To: Shay McDonald
From: Tim Baker
Company: Otago Regional Council
SLR Consulting New Zealand
cc: Samantha Iles
Date: 24 October 2024
Project No. 820.V13556.00001

**RE: RM23.185 - Green Island Landfill
Groundwater Quantity and Quality Technical Memorandum 02**

Figure 1 Recommendation for the location of the new monitoring well cluster

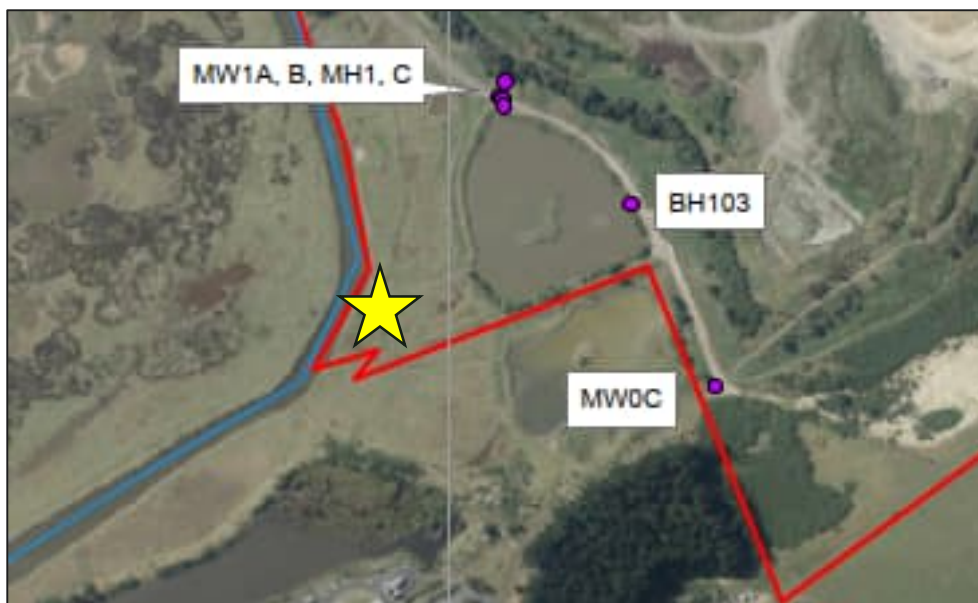
The addition of BH103 to the monitoring programme is supported. However, I would like to see further deep wells added, at a minimum, to monitoring lines 1 and 3. This would provide a continuous network of deeper wells around the 'down-gradient' side of the landfill.

A further set of monitoring wells covering the three main geological units (including the Abbotsford formation), in the southwest corner of the property, is also recommended. A suggested location is shown below on Figure 1. This location would provide more information on the potential for off-site migration of leachate, and is aligned with the historic estuarine channel locations, which may form preferential flow paths.
